CHARTER TOWNSHIP OF ORION PLANNING COMMISSION REGULAR MEETING AGENDA WEDNESDAY, AUGUST 16, 2023 - 7:00 PM ORION TOWNSHIP MUNICIPAL COMPLEX BOARD ROOM 2323 JOSLYN ROAD LAKE ORION, MI 48360

| 1. OPEN MEETING | 2 |
|---|-----|
| A. PC-23-27 Black Cat Beanery Special Land Use for a cat cafe, located at 1192 S. Lapeer Rd. (parcel #09-14-201-025). | 16 |
| B. PC-23-20 WhiteWater Car Wash Site Plan, located at 1112 and 1140 S. Lapeer Rd. (parcels | 65 |
| C. PC-23-22 Yatooma Oil Gas Station and Drive-Thru Special Land Use and Site Plan, located on | 139 |

PHOTOMETRIC PLAN

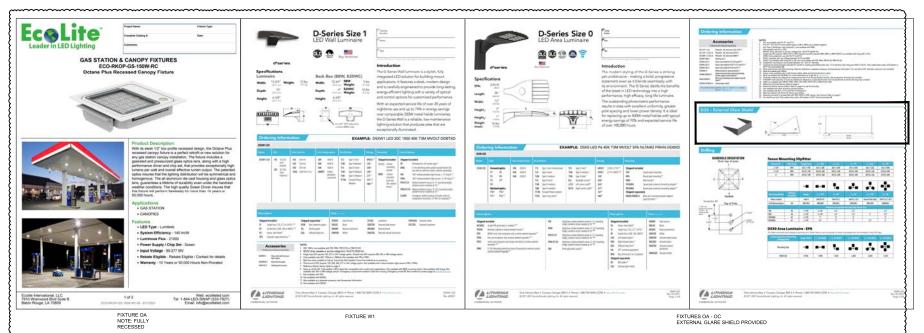
Lighting standards are contained within Sec. 27.11 of the Zoning Ordinance. A Photometric Plan (Sheet PH100), and Light Fixture Cutsheets (Sheet PH101) have been submitted.

The lighting information shows proposed pole-mounted parking lot lighting, recessed light fixtures under the gas pump canopies, goose-neck fixtures mounted on the front and south side of the building, and wall-mounted fixtures on the other two facades of the building. The building elevations on Sheet A200 is consistent with the Photometric Plan. However, Sheet A201 shows additional light fixtures above the pedestrian doors on the west building façade, but these fixtures are not shown on the Photometric Plan. Also, the type of fixture above the pedestrian doors is not identified. Could they be modified gooseneck fixtures? The applicant should clarify the type of fixture, and they should be added to the Photometric Plan.

- 1) Confirm lighting proposal on PH100, Photometric Plan, or on Sheet A201, Exterior Elevations. Light fixtures on Sheets A200 and A201 have been corrected to match PH100.
- 2) Provide legible manufacturer sheets for D-series fixtures.

Sheet PH101 added to provide more legible fixture cut sheets.

GAS CANOPY
PLAN AND
ELEVATIONS
PROJECT NUMBER
2023-108
SHAWAN BY:
KMB

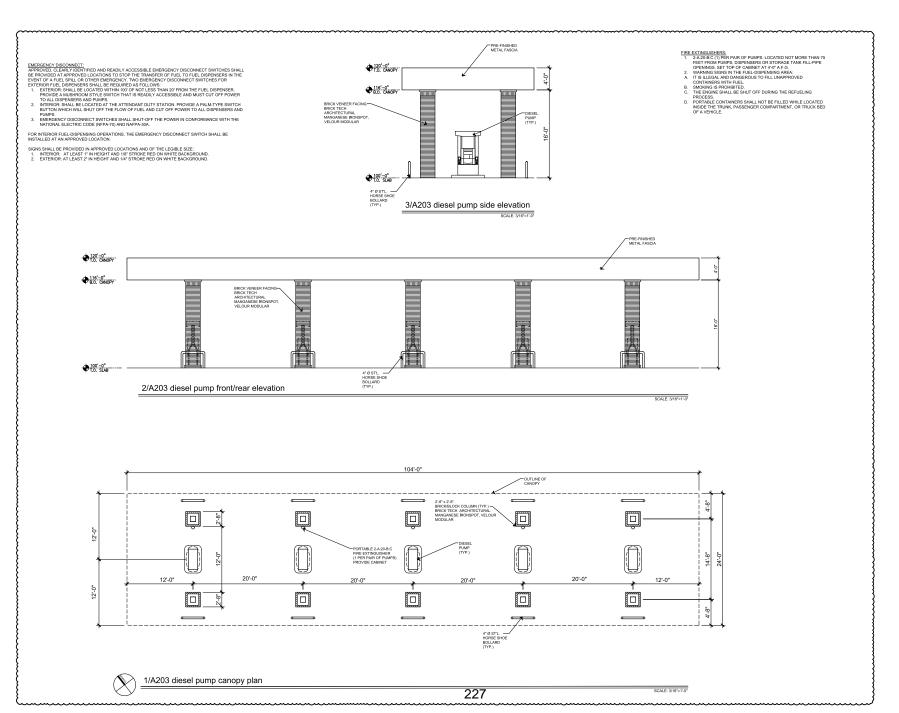
2) Provide elevations of proposed gas pump canopies to confirm height meets ordinance requirements. Gas canopy plans and elevations are provided on Sheets A202 and A203. The under-canopy height for both canopies is 16'-0".

Gas and Diesel Canopy plans and elevations have been provided on Sheets A202 and A203. The canopy height for both canopies is 16'-0".
- Proposed slopes near the northwest and southwest corners of the site exceed the Township maximum recommended slope of 1:4 and will need to be revised.
 Proposed slopes near the northwest and southwest corners of the site have been updated to maintain a maximum slope of 1:4.
- 10. An oil/water separation device shall be included in the storm management plan.
